Product Change Notification

Change Notification #: 107541 - 00
Change Title: Intel® TXN13600/TXN13610 Tunable Laser Transponder, PCN 107541-00, Product Material
Date of Publication: May 11, 2007

Figure 1: Transmit Boot extension of TXN13600/TXN13610 transponders. The receive side remains unchanged.

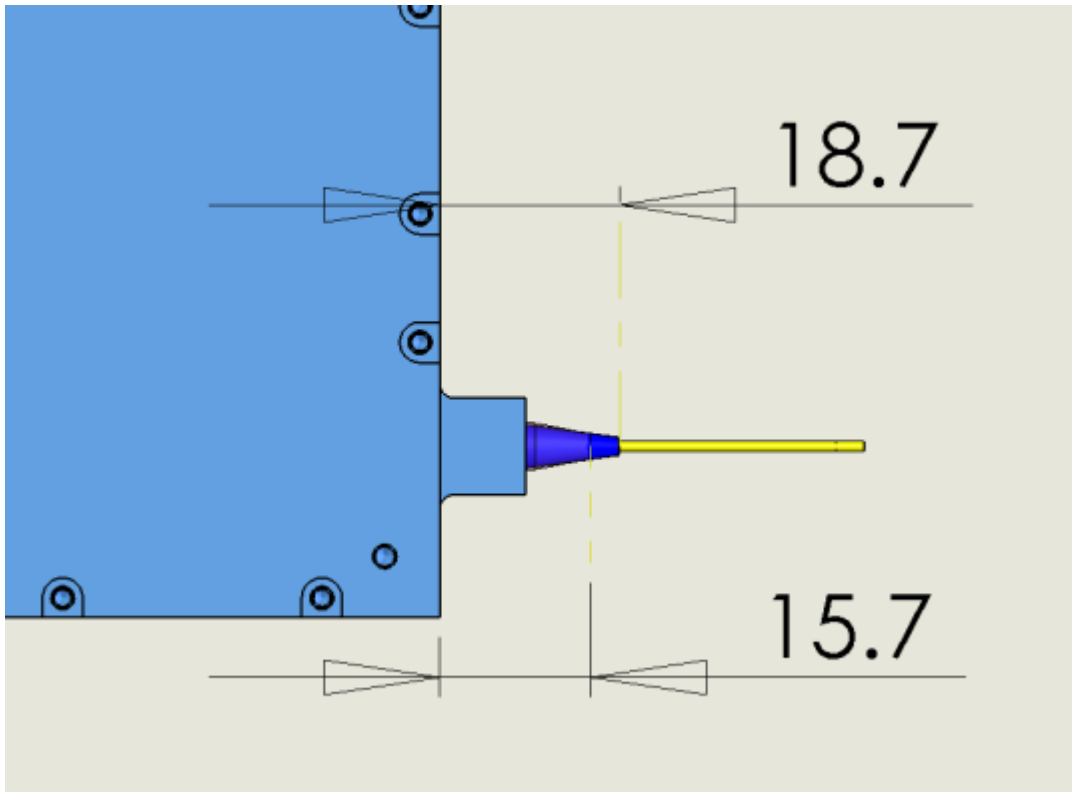
Intel's component vendor is modifying the fiber boot on the transmit side of the Mach-Zehnder modulator for more robust fiber handling. The change is limited to a transmit side fiber boot length increase of 3 mm. Figure 1 demonstrates the increase in boot length from 15.7 mm to 18.7 mm.
